Comment Letter RI5

Google Earth showing radius emanating from proposed development site equaling half the claimed average trip distance.

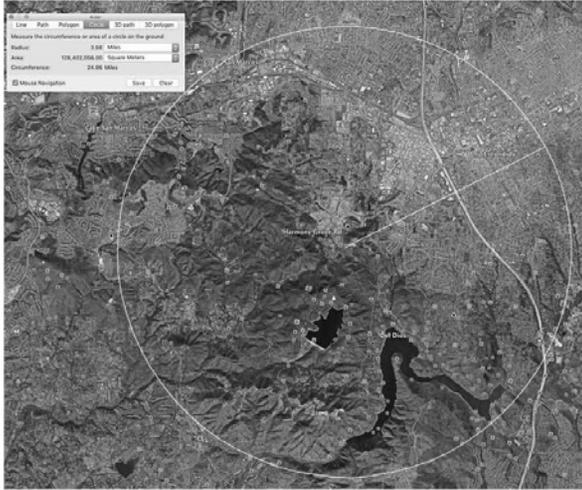
This EIR fails to meet the States GHG laws and thus the project may not be approved. The developer proposes an ad hoc methodology that is not adequately supported by evidence showing how it is consistent with the 2011 General Plan or how its implementation in San Diego County would meet the States GHG laws. In fact it is an attempt to cast aside the 2011 General Plan based on what can only be described as dubious logic. A fact that is shocking given that the residence of the county overwhelming reaffirmed their support for the General Plan in last years vote rejecting Lilac Hills attempt to seek a waiver of it. The analysis both understates the total GHG produced by the development with a traffic study analysis that is unrealistic and greatly understates the average trip distance in and out of the proposed project. And ignores all indirect GHG the project would create. By the developers own admission the propose mitigation would not reduce GHG as the County is required by State law. Due to the extremely misleading analysis and failure to address indirect sources of GHG, it would significantly increases the Counties GHG output.

These comments generally are conclusion comments, summing up some of the points made in the letter; please see Responses to Comments RI5-2 through RI5-5 of this letter. The reference to Lilac Hills is noted, but a vote against a specific much larger and mixed use project in a different location east of I-15 and with different environmental constraints and opportunities is not pertinent to the specifics of the Harmony Grove Village South Project. With respect to the comment that the developer proposes an ad hoc methodology that is not adequately supported by evidence showing how it is consistent with the 2011 General Plan or how its implementation in San Diego County would meet the state GHG laws, please see the Global Responses to Climate Action Plan.

The comment also contends that the traffic study analysis is “unrealistic and greatly understates the average trip distance”; and that the analysis “ignores all indirect GHG the project would create.” However, the comment offers no specifics related to these unsubstantiated conclusions.

It is noted that the Project Traffic Impact Analysis (TIA) has been reviewed and commented upon and is not a subject of recirculation. The County disagrees that the TIA was unrealistic or that average trip distance was underestimated. In fact, the average trip distance was modeled in conjunction with SANDAG input for the Project. It is also noted that following public review, a request for review of specified TIA elements (including such items as baseline traffic loading, and distribution to I-15 and SR-78) was received. Each of those items was reviewed and memoranda regarding these topics are part of the Final TIA (Appendix D to the FEIR). No changes to CEQA conclusions or proposed mitigation were required as a result of these focused reviews. While providing some clarification, they were all confirmatory in nature. As stated in Subchapter 2.7, *Greenhouse Gas Emissions*, of the EIR, and as supported by modelling discussed in Appendix C of EIR Appendix J, the Project VMT is projected to be 7.88, just within the regional average identified by SANDAG.
